PZSITE2024-00009

Iglesia Bible Church Site Plan - S. 25th Street

TRC Meeting

RESPONSE LETTER

Enclosed Dumpster Detail (NTS)

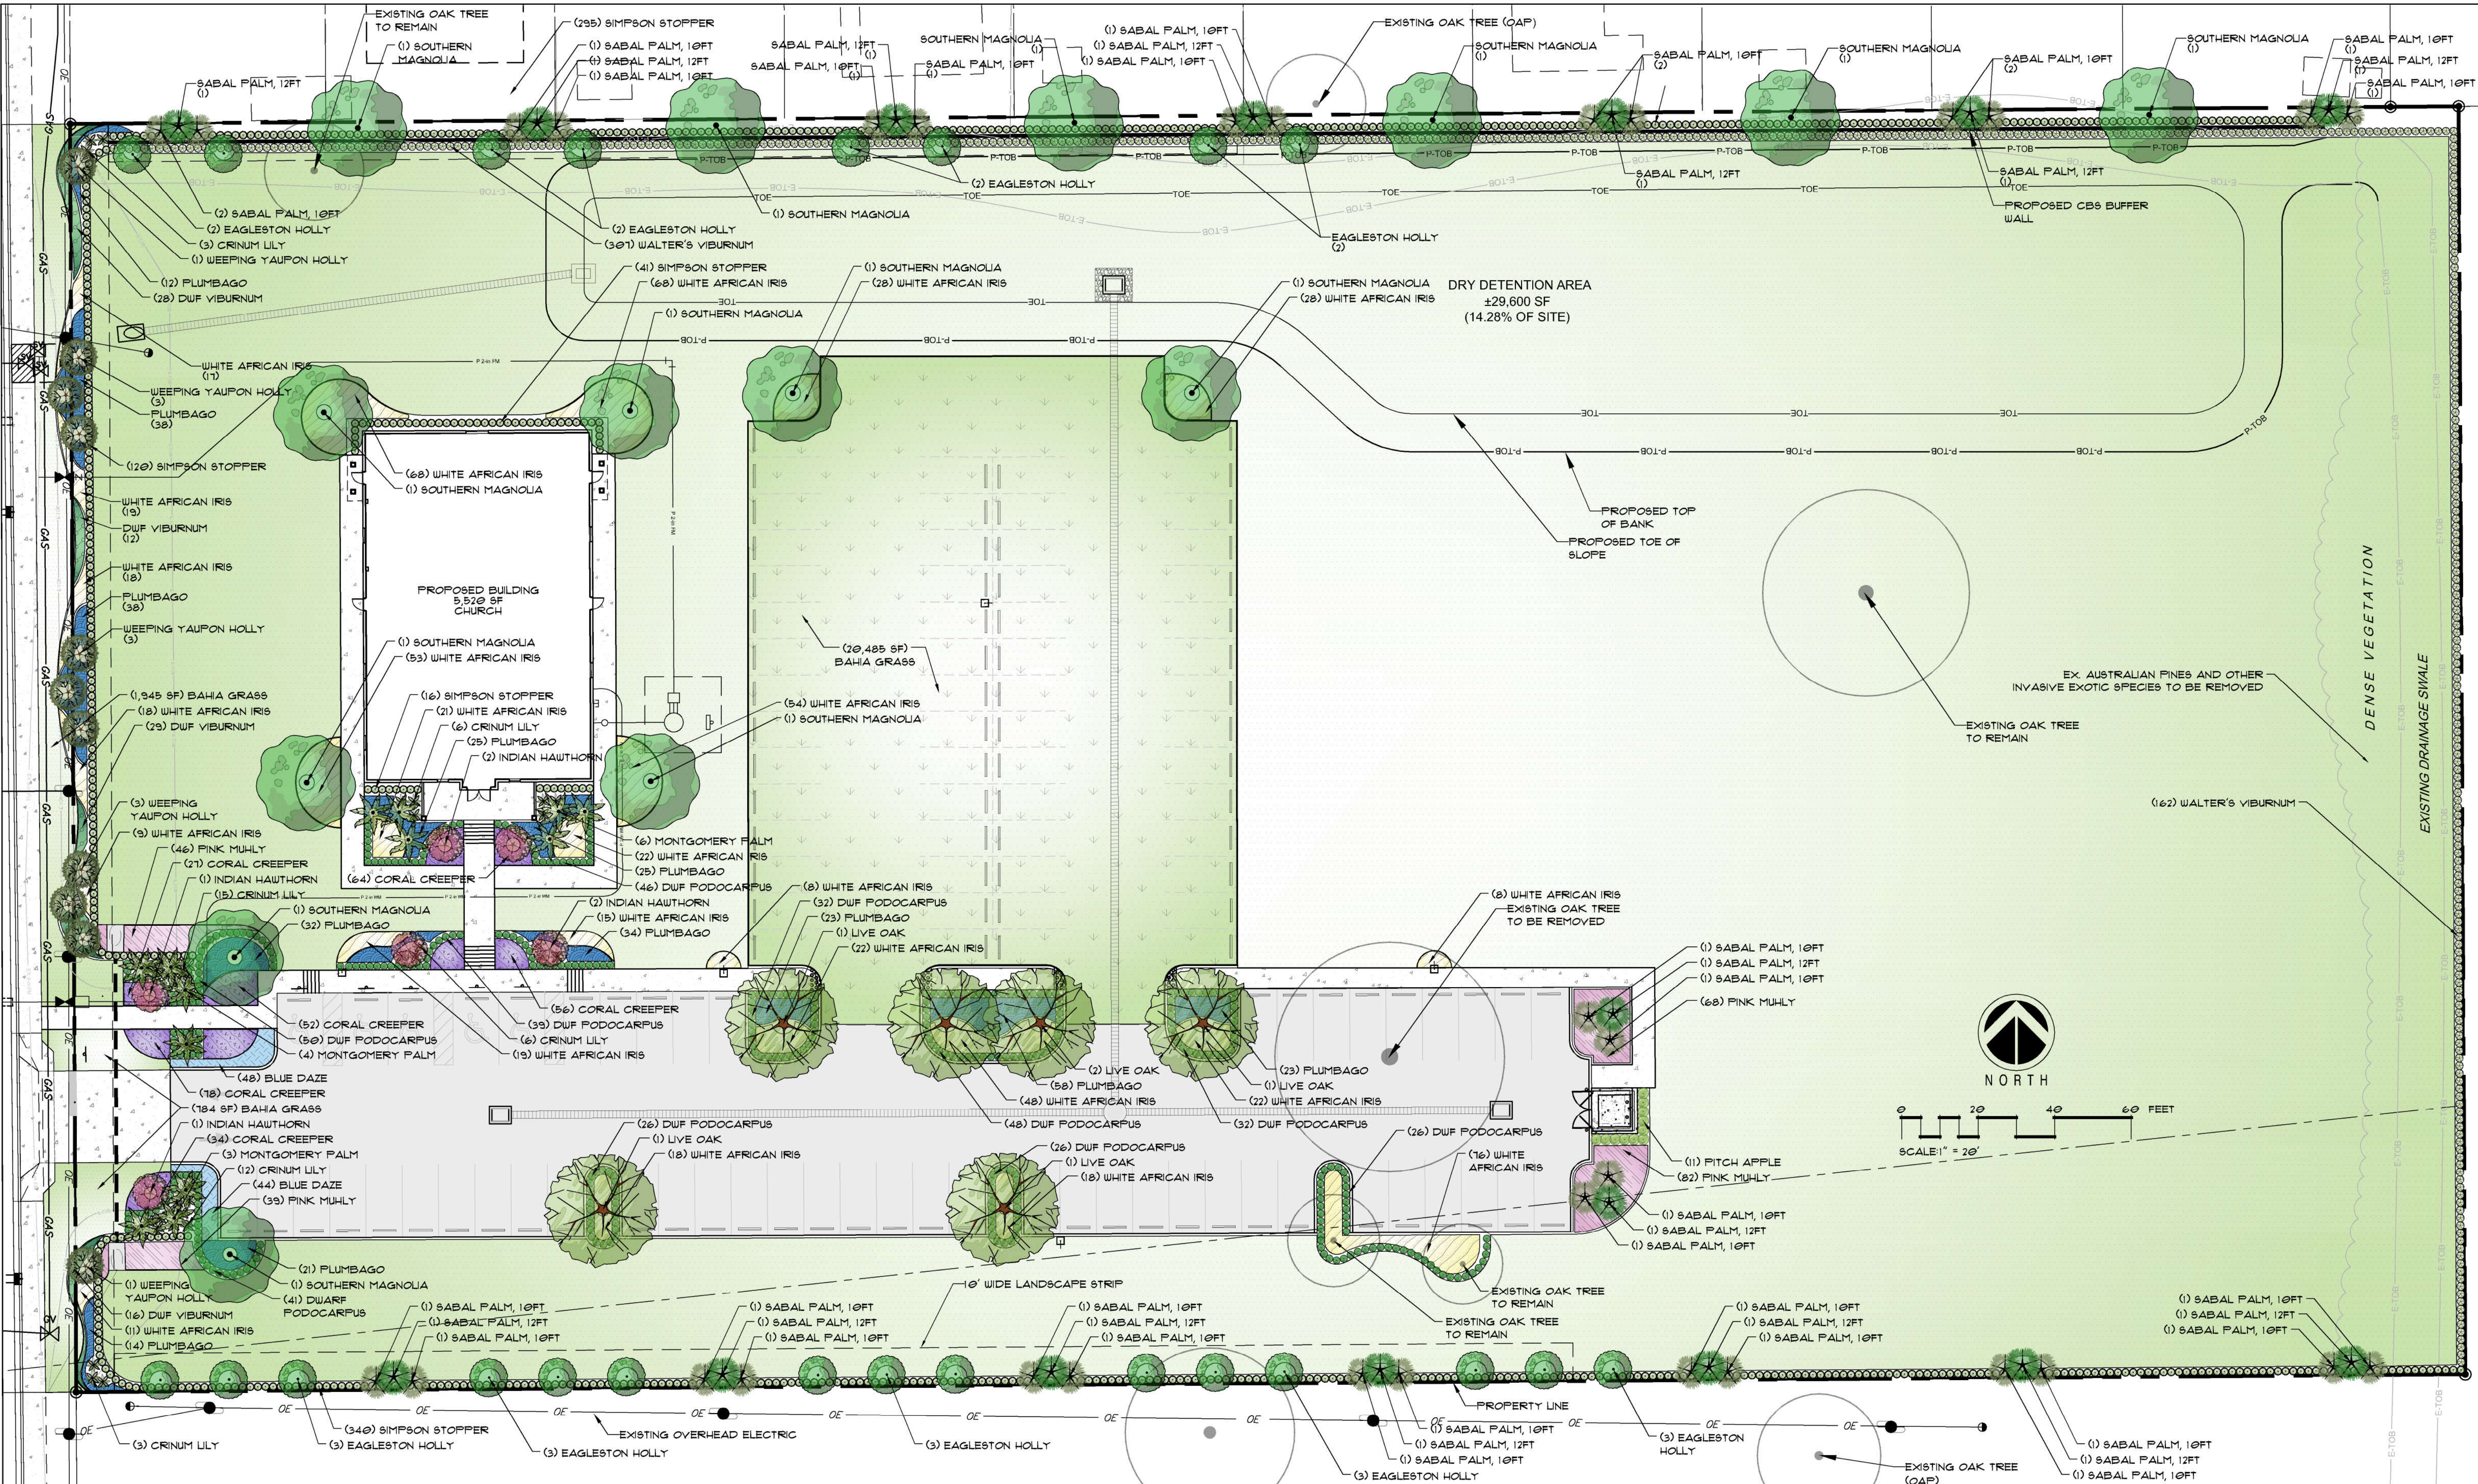
Comment	Update the Dumpster Detail to reflect the required separate pedestrian access, detail attached.
Response	Provided on the Sheet 2 of the site plan

Comment	Update the Dumpster Detail to reflect the required separate pedestrian access
----------------	--

Response	Updated
----------	---------
